DOCUMENTATION TRANSMITTAL

Documentation Description: Nonconformance Reports -
C-03732
C-03736
C-01006

MIDLAND PROJECT
QUALITY ASSURANCE
DEPARTMENT

NONCONFORMANCE REPORT

Draw # 109 (C)

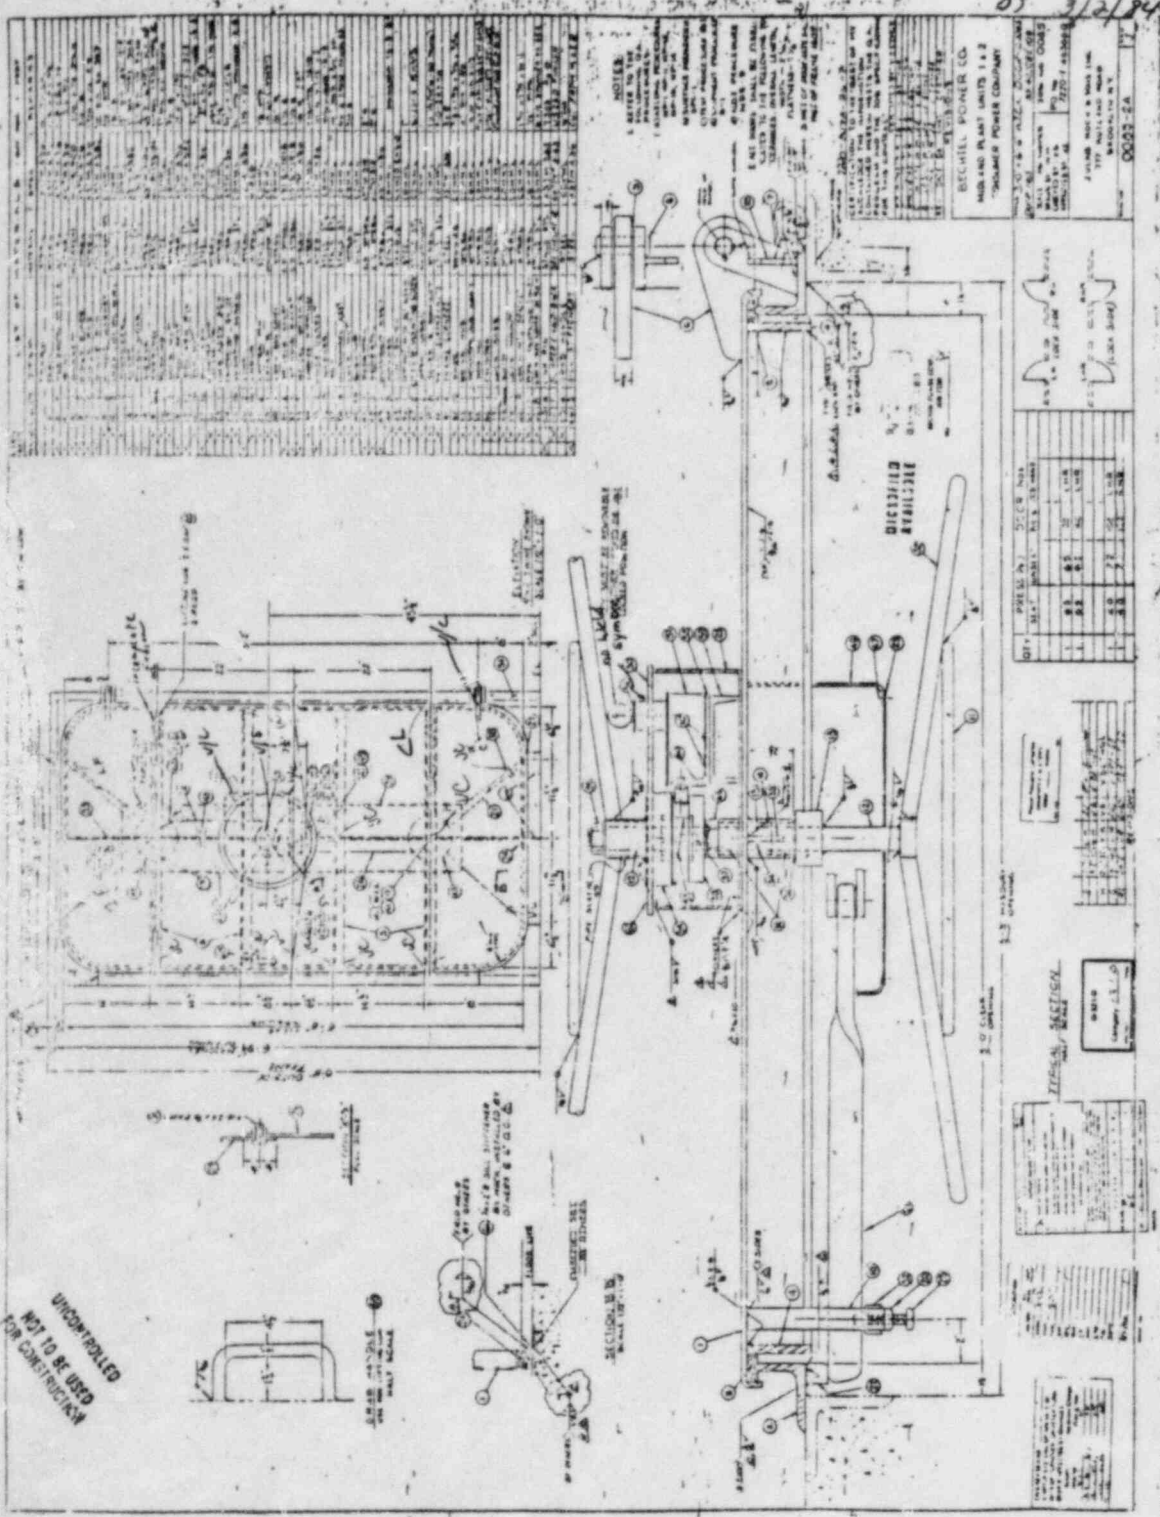
F.F. = incomplete Finish
 C.L. = Cold Lap
 SLAG = slag
 4/8 = undercut
 4/5 = under size

Draw # 53 (C)

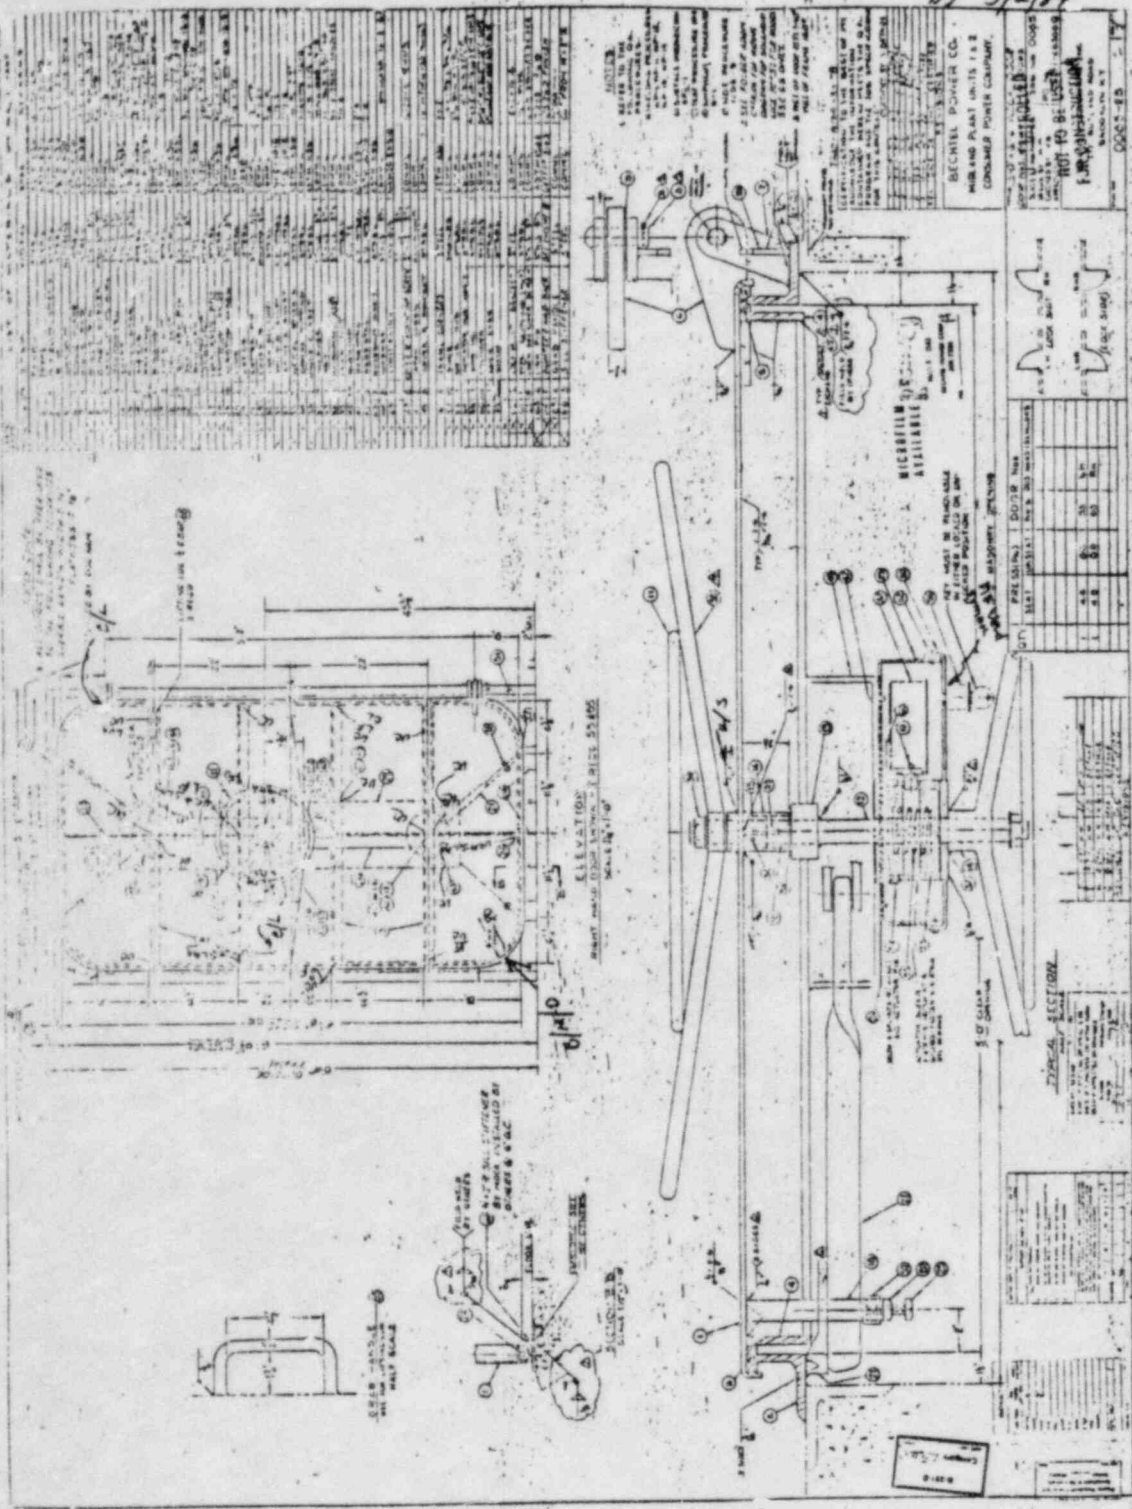
C.L. = Cold Lap
 P.O. = Porosity
 L.F. = Lack of Fusion
 4/2 = Undercut
 4/5 = Under Size
 4/7 = Under Fill

①
 Plan # 25

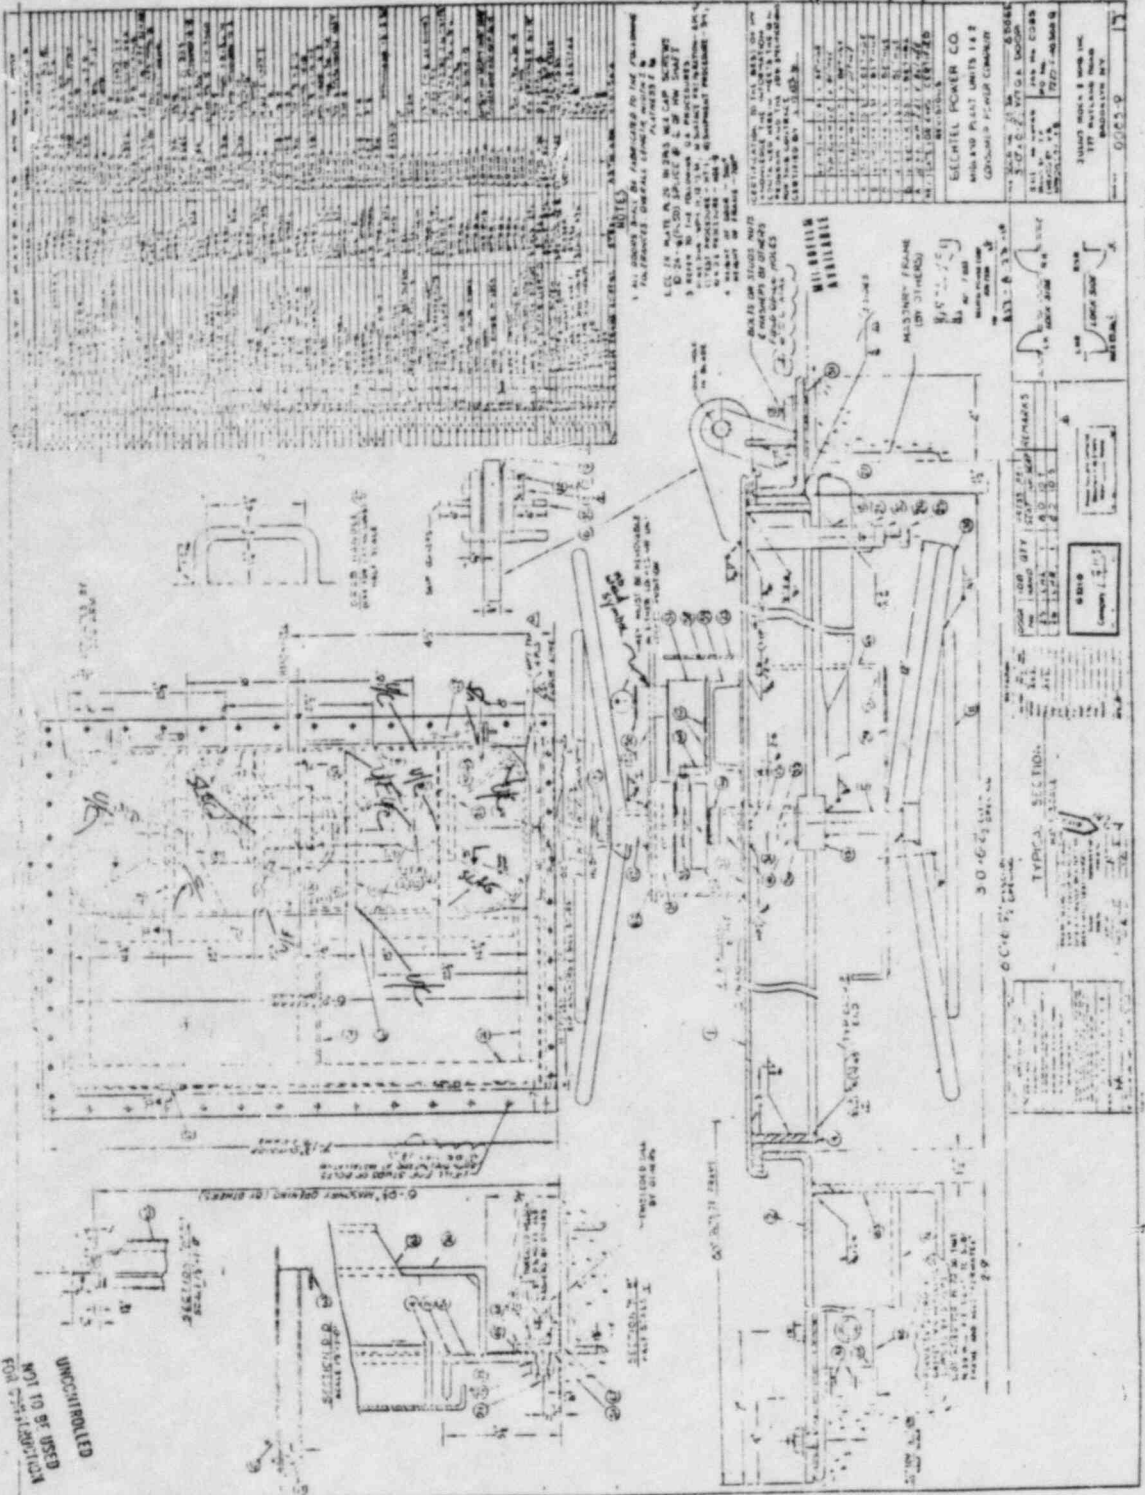
4/F = under full
 4/C = under cut
 4/S = under size

Draw # 15 (C)

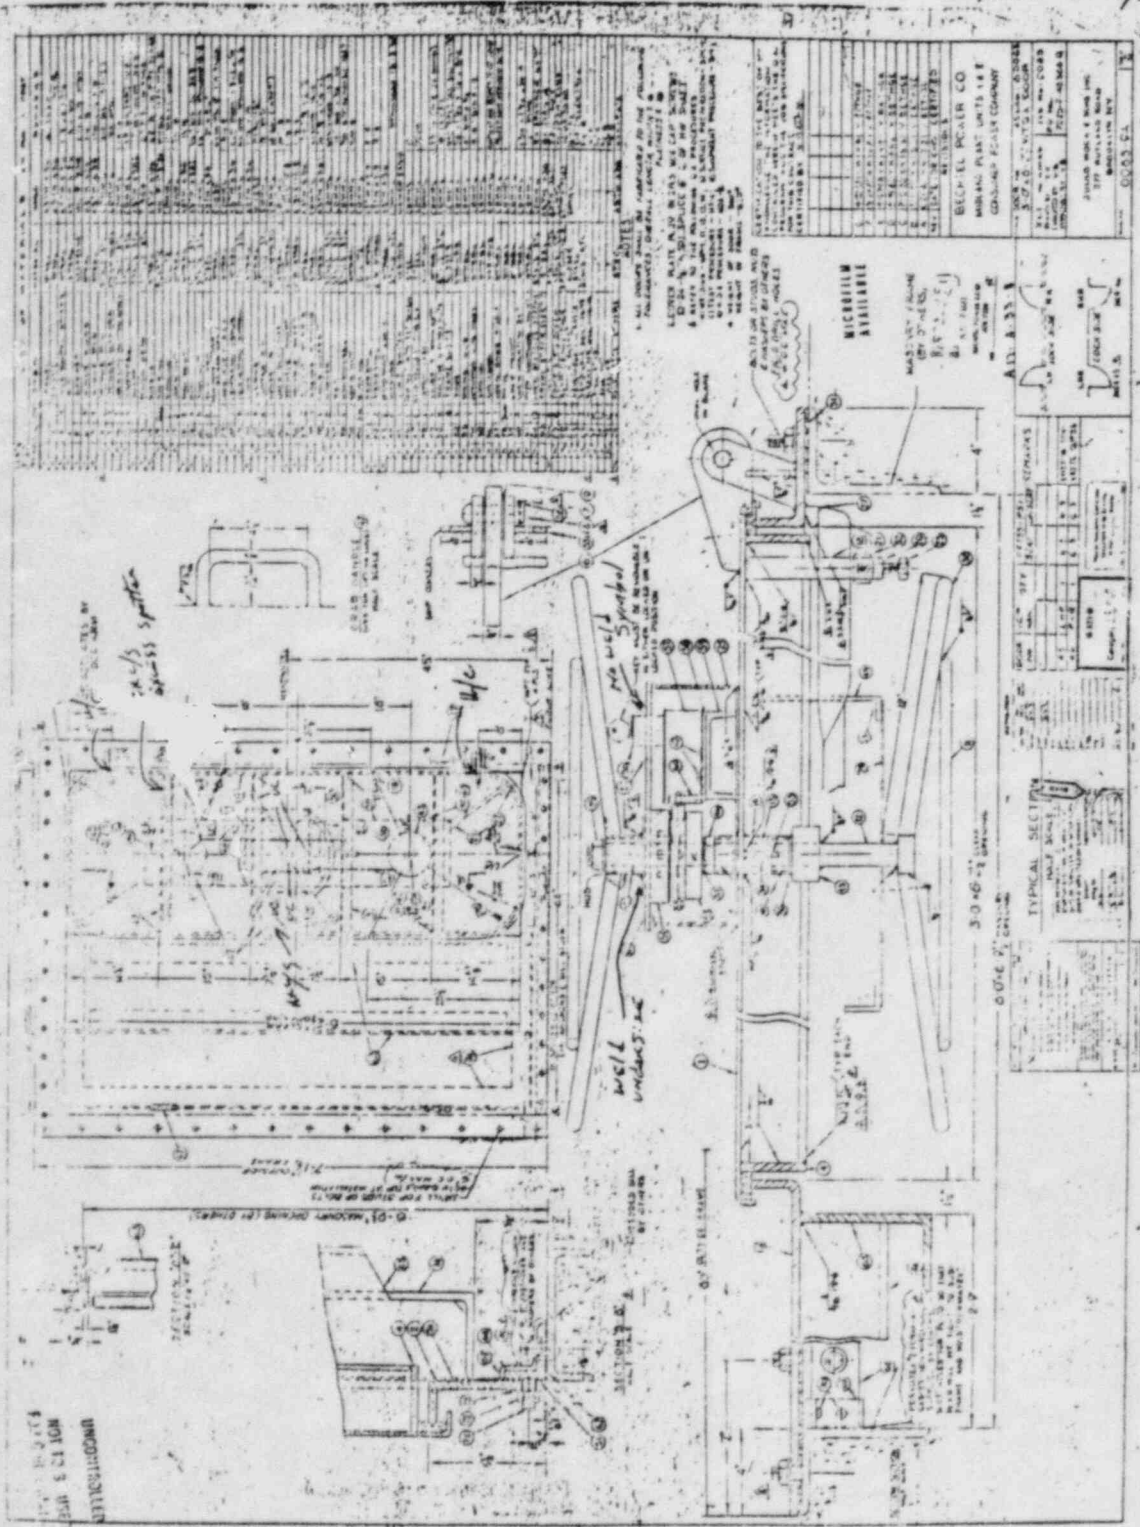
WC = undercut
 L/F = Lack of Fusion
 C.L. = Cold Lap
 A/S = arc strikes
 U/S = under size

Q 402 # 45 ©

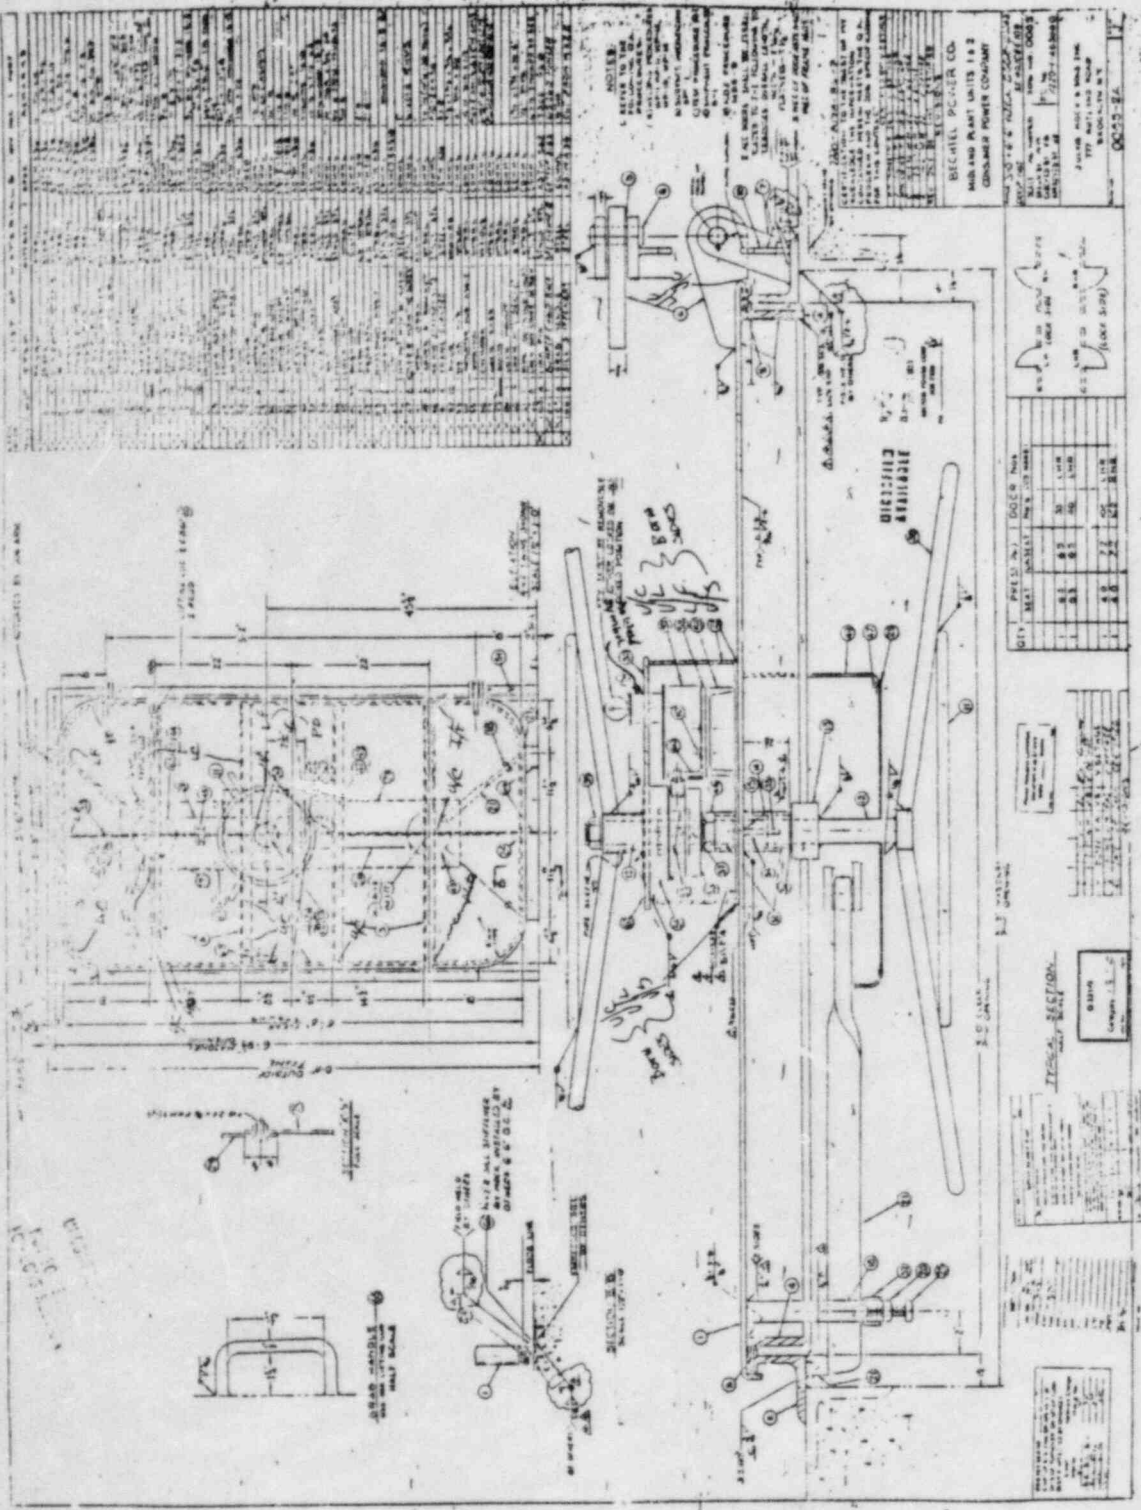
4/c = undercut
 arc = arc strikes
 w/s = welds
 P.O. = Porosity

Rev # 108

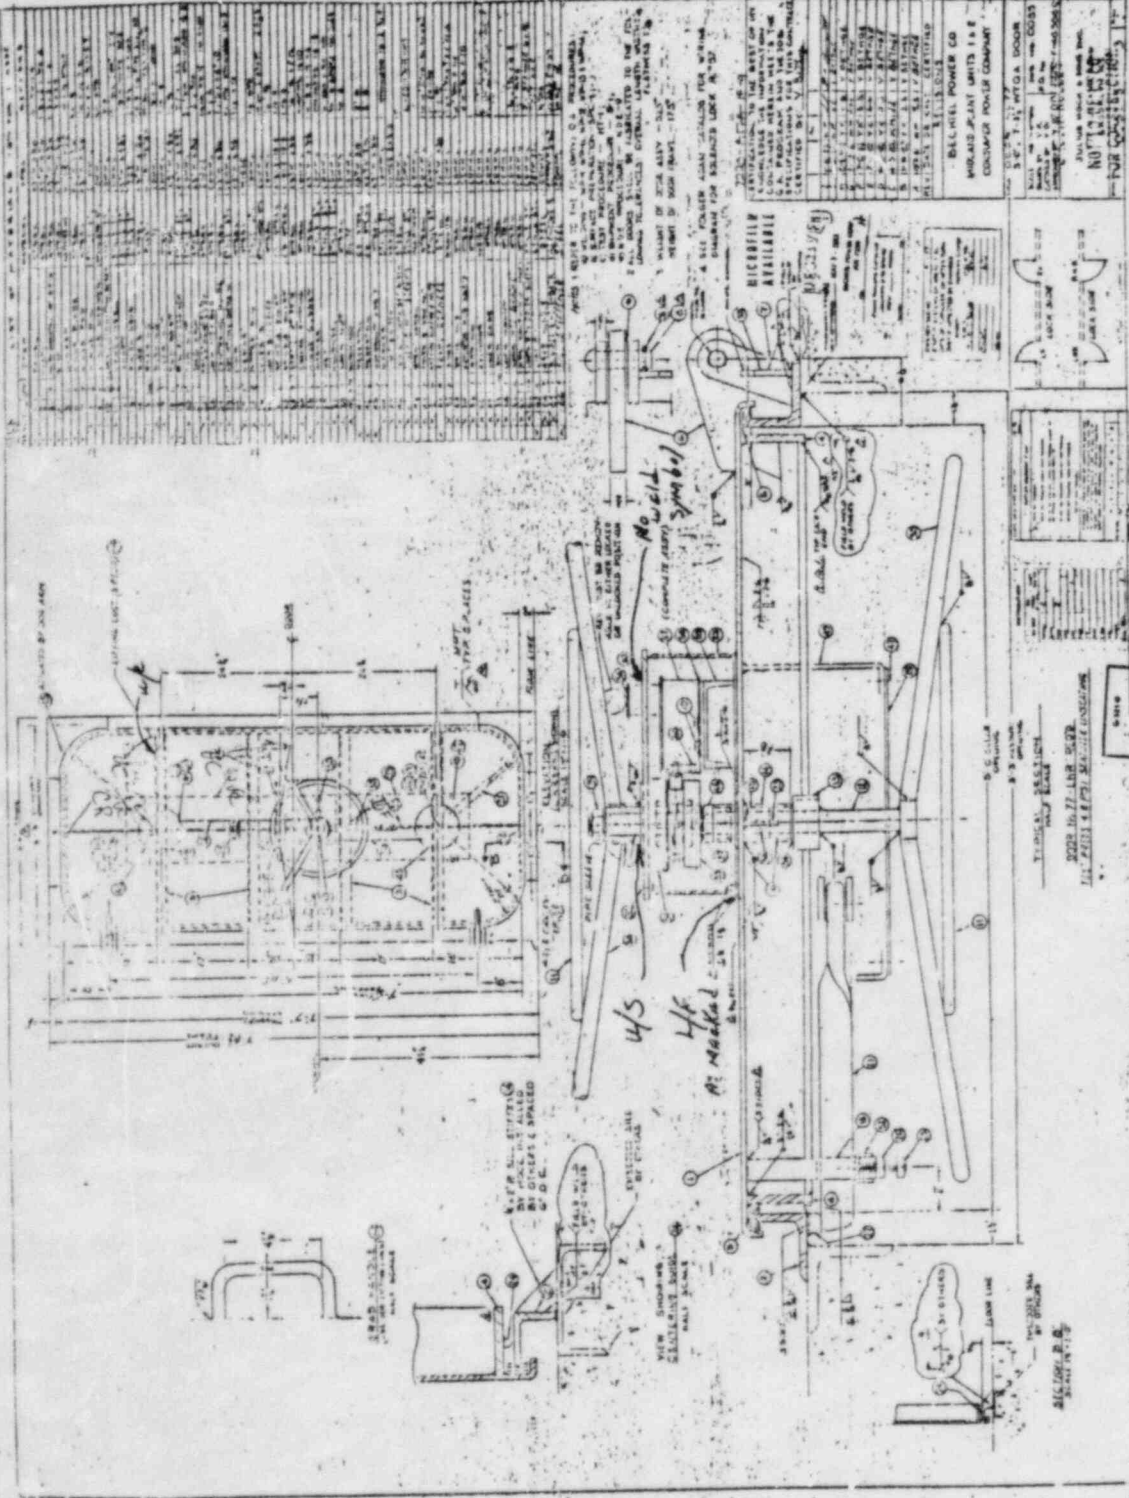
4/c = undercut
 4/s = under size
 4/l = under length
